STATE OF WASHINGTON
DEPARTMENT OF ECOLOGY

October 6, 2015

Re: Opinion on Proposed Cleanup of the following Site:

- **Site Name:** Woodworth & Co. Lakeview Plant
- **Site Address:** 2800 104th Street South, Tacoma
- **Facility/Site No.:** 1372
- **Cleanup Site No.:** 165
- **VCP Project No.:** SW1012

FIGURE 7

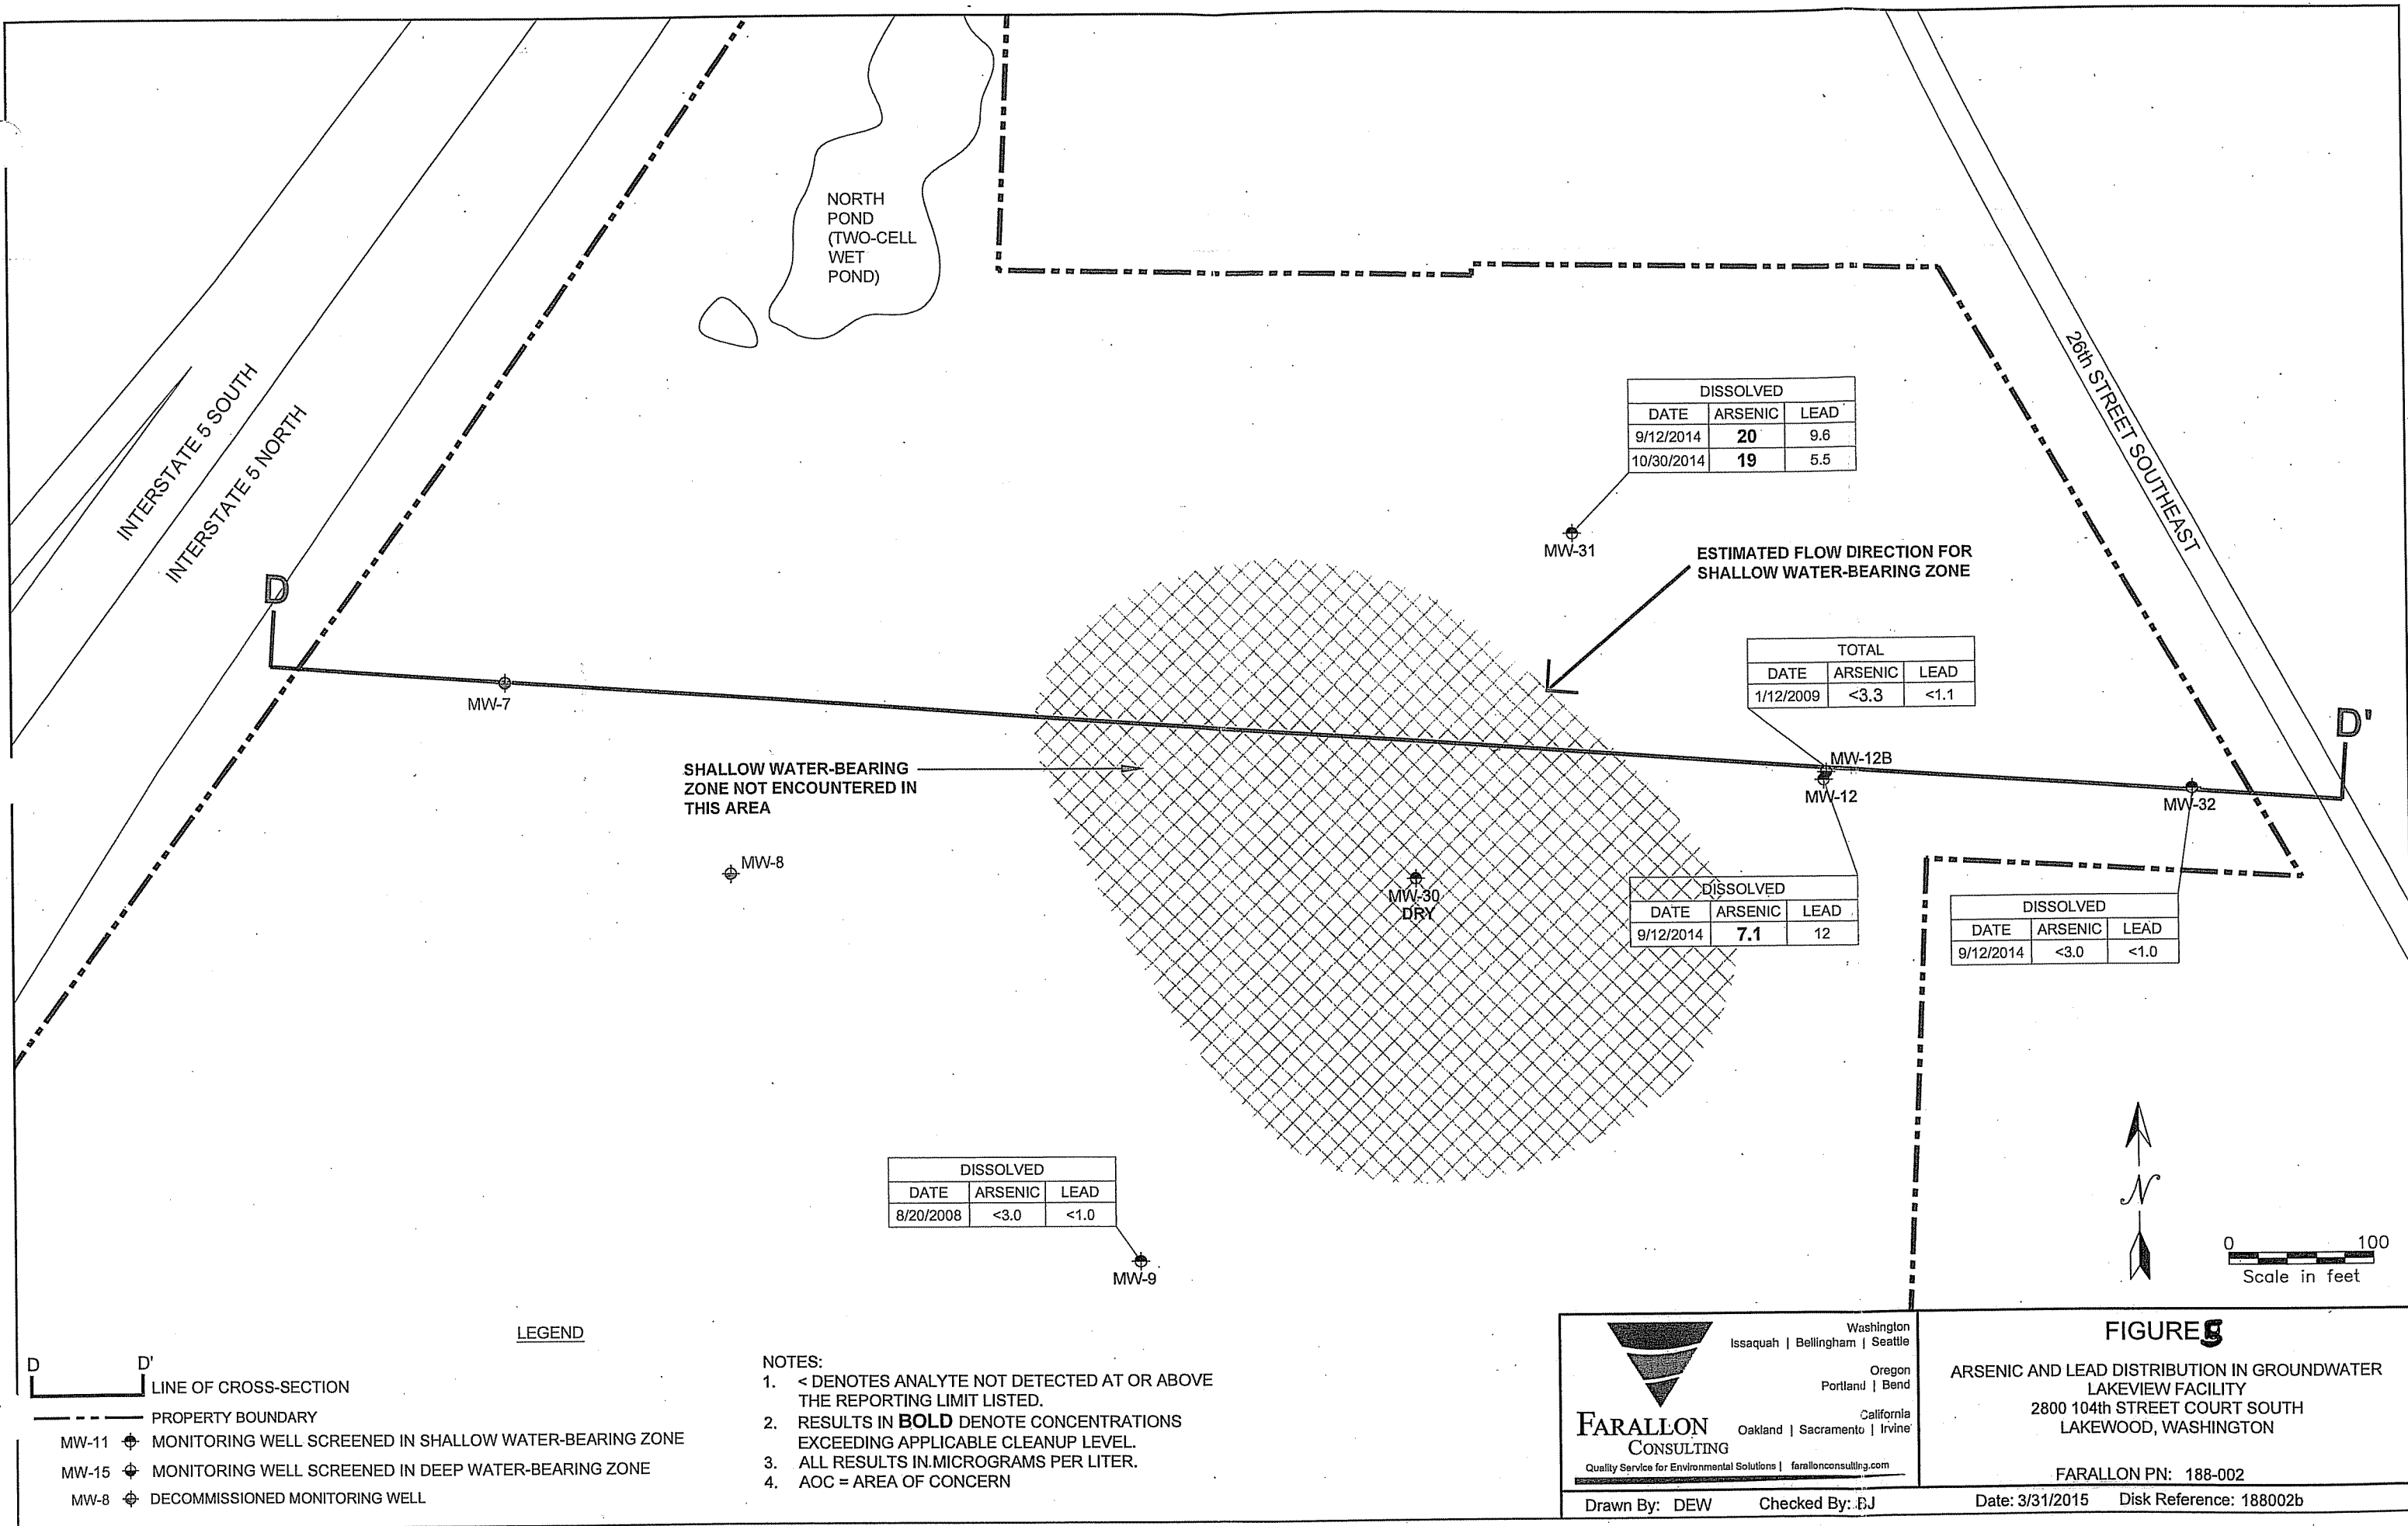
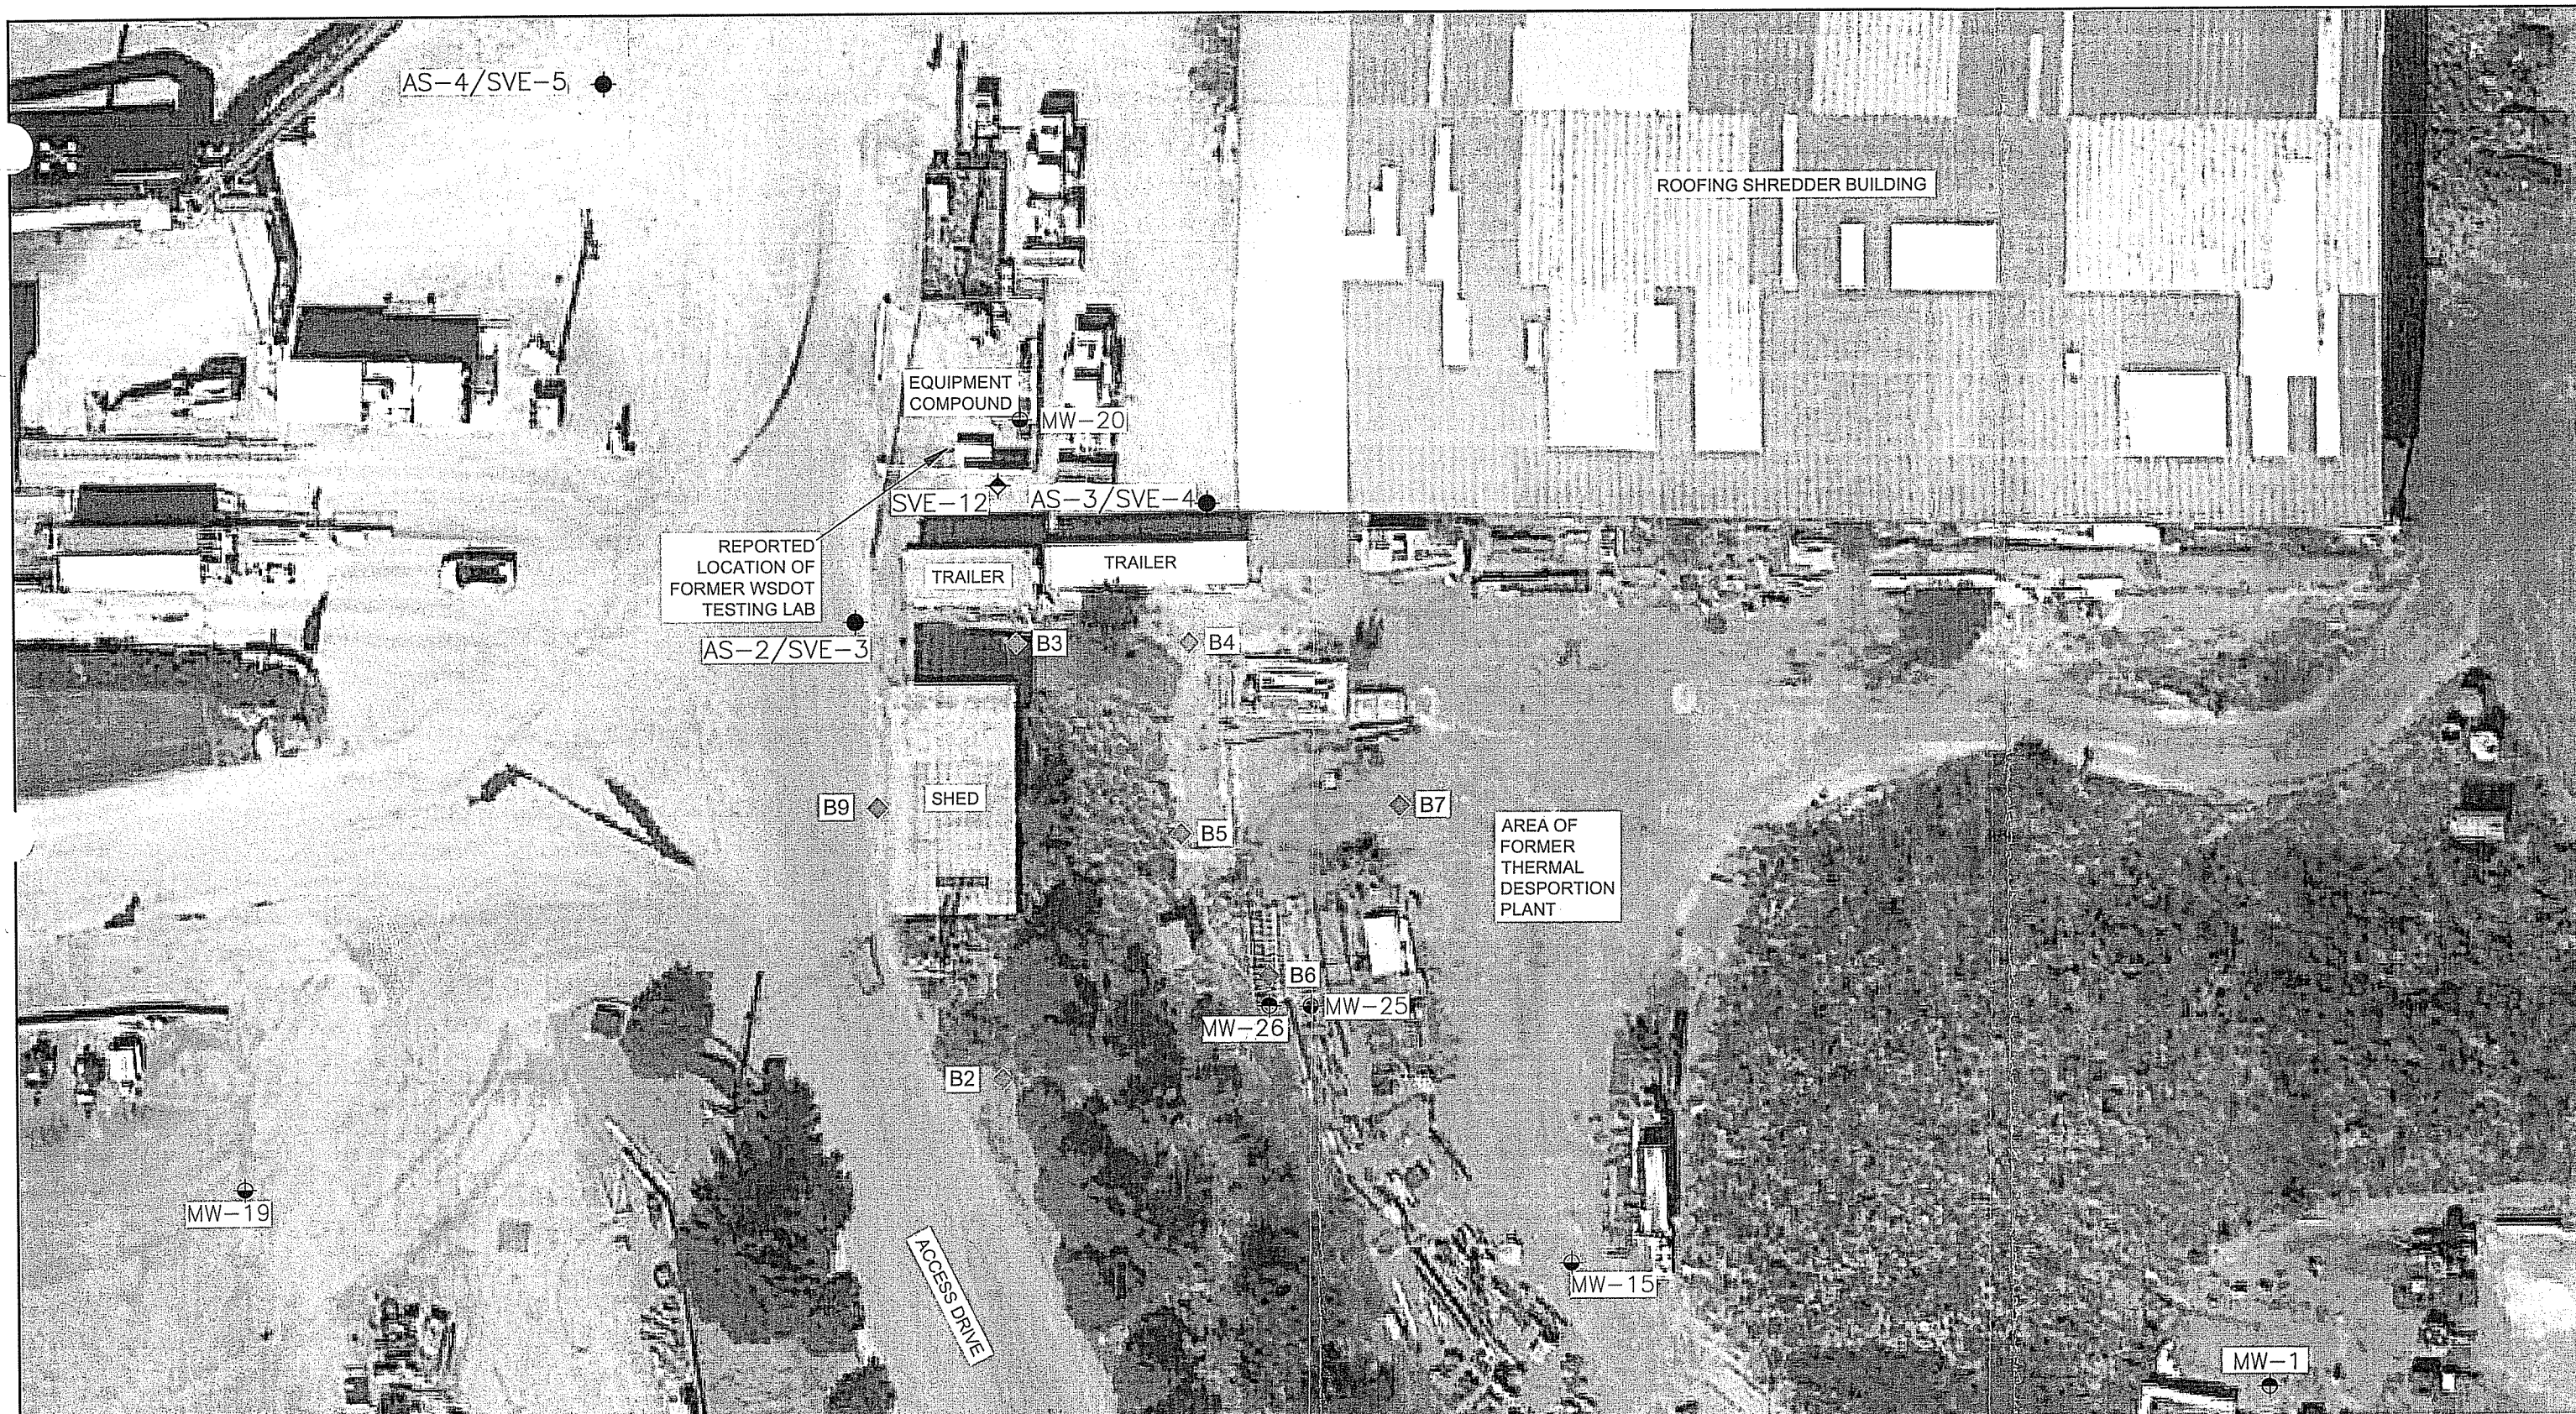
1. AOC 4 is not sufficiently characterized for remedy selection. Additional soil samples need to be collected in the area of the former DOT asphalt testing laboratory, since this is the presumed TCE source area (Farallon, April 2015). Remedy selection cannot begin until further investigation of the source area soils is completed. In particular, please collect soil samples from the upper portion and within the silt/silt and sandy gravels (as shown on Figure 7 in the Farallon April 2015 report), beneath and immediately adjacent to the former DOT laboratory.
